Product Change Notification

Date Issued :	September 17, 2022	PCN Number :	512567
Reason for Change :	Change Supplier		
Description of Change :	This notification is to inform you about change of supplier impacting the part(s) attached as per list, No changes will be made to product as part of this change.		
Reason for Short Notice :	Supplier Constraints		
Assessment of Change :	First Article Inspection		
Planned Implementation Date :	December 20, 2022		
Sample Availability Date:	October 02, 2022		
Internal Molex Qualification Date :	December 05, 2022		
Last date to request Samples by Customer :	November 30, 2022		
Traceability Code Markings / Date :	Date code

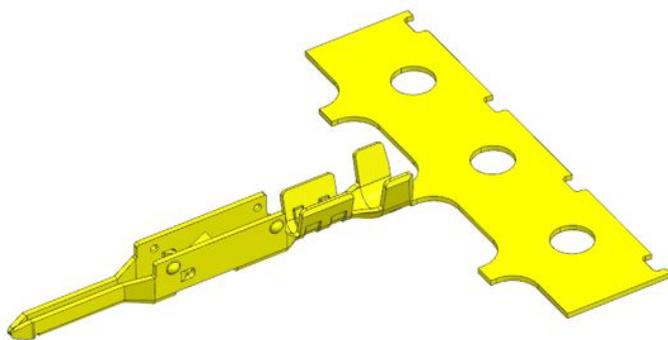
- Because current vendor Kemper stopped producing C19210 and C42500 metal alloy, we must qualify new source Boway to keep production running. Metal alloys are not changed. Boway is one of local metal supplier in China.
- Product Impact
 - no impact to fit, form or function
 - ✓ Before: C42500 WOP 0.200 X 22.00(HR06) P/N: 648971372
 - ✓ After: C42500 WOP 0.200 X 22.00(HR06) P/N: 648971372
- ✓ Product will be fully qualified before it is shipped. Qualification reports will be available after below listed date.
